***SECTION 96(1A) MODIFICATION APPLICATION
ASSESSMENT REPORT***

***Waterfront Promenade & Interim Public Domain
Works (SSD5374 MOD 1)***

Secretary's
Environmental Assessment Report
Modification of consent under section 96(1A) of the
Environmental Planning and Assessment Act, 1979

Figure 5: Section through foreshore promenade detailing the proposed modification (MOD 1)

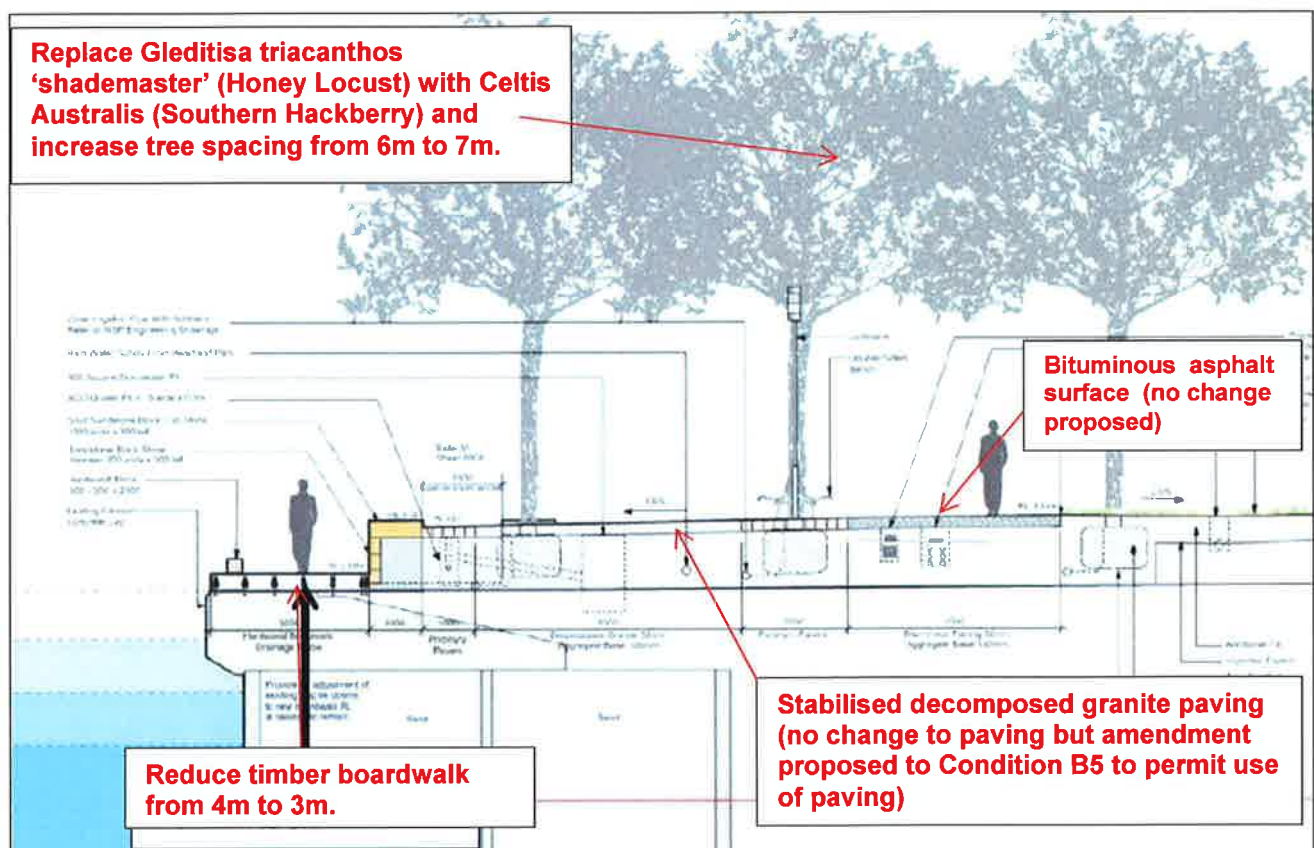
- a reduction in the width of the timber boardwalk from 4 metres to 3 metres;
- the deletion of the feature sandstone cladding on the new seawall adjacent to the public deck as a result of a reduction in the finished level of the foreshore boardwalk and the public deck; and
- changes to the landscaping, including to the promenade tree species and planting details.

In addition to the above, the application seeks approval to modify Condition B5 (paving materials) to permit the use of decomposed granite paving material along the promenade despite the material not technically complying with AS/NZS 4586:2004- 'Slip resistance classification of new pedestrian surface materials'.

Figure 7: Proposed design detail for the foreshore promenade (source: PWP Landscape Architecture)

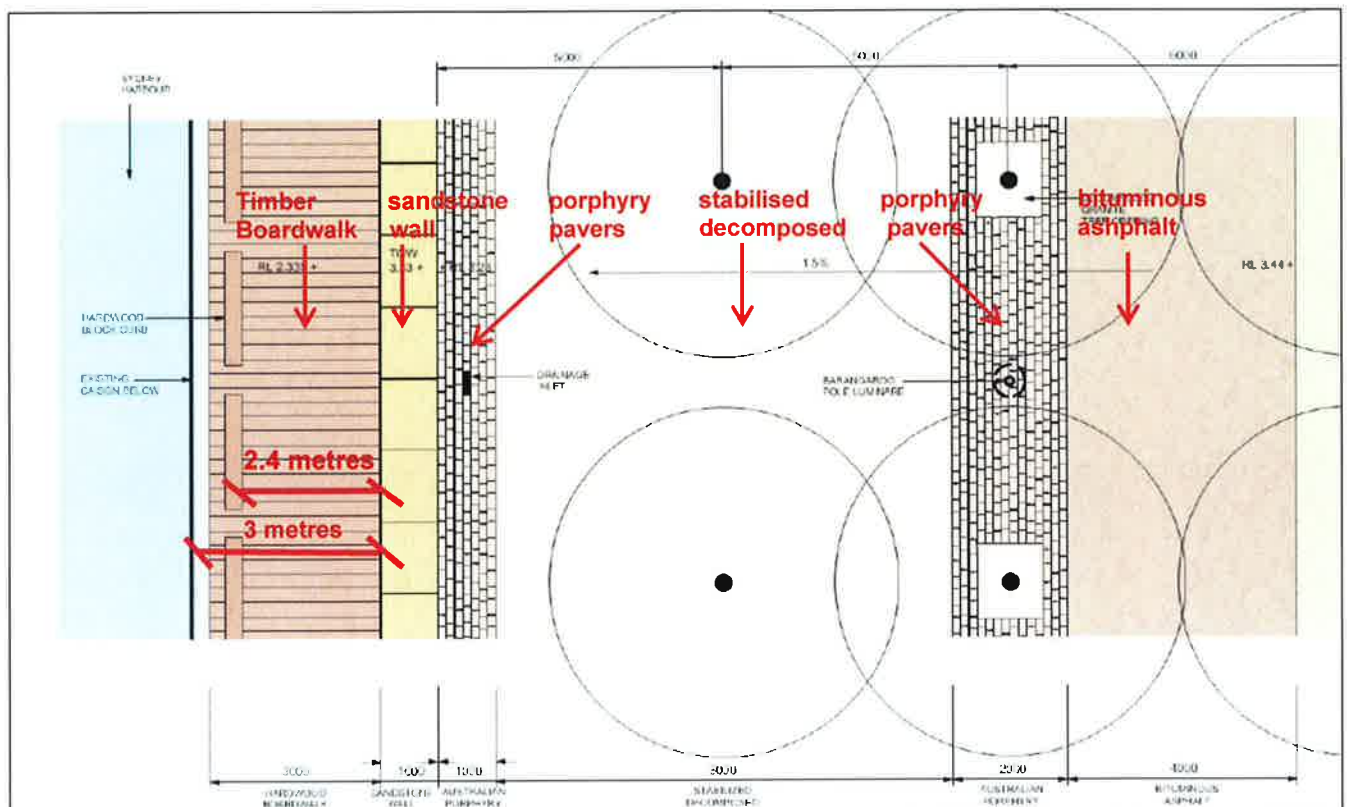
- The approved width of the boardwalk for Stage 1A of Barangaroo South is 4 metres and the width of the boardwalk for Stage 1B of Barangaroo South (including the Casino foreshore) is unknown. Further clarification is therefore requested to justify the reduction in the width of the boardwalk to 3 metres. Unless genuine justification can be provide, the reduction in width should not be supported.

- The reduced width will be problematic for a number of users. Although, the boardwalk is billed as a secondary path, it will nevertheless be highly attractive. The reduced width will also contribute to the walkway appearing out of scale with the sheer length of the waterfront.

- The reduced width of 3 metres does not reflect the true width available to users. The width will be further reduced to approximately 2.4 metres once obstacles like the proposed hardwood blocks are included. In the event that 3 metres is supported by the Department, the true width available to users should be 3 metres for the volume of users expected.

MOD 1 proposes to amend the design of the timber boardwalk by reducing its approved width from 4 metres to 3 metres. Given the design for the boardwalk retains the approved hardwood block edge to the water, this would mean that the effective width or usable surface of the boardwalk would be reduced from 3.4 metres to approximately 2.4 metres, as illustrated in **Figure 7** below.

As detailed in the Section 4.0 of this report, both the Department and Council have identified that the timber boardwalk as detailed in MOD 1 has been constructed. Notwithstanding this, it is relevant that detailed consideration be given to the reduced width of the boardwalk and furthermore, whether this amended design achieves the design intent of the Barangaroo Concept Plan. In response to these
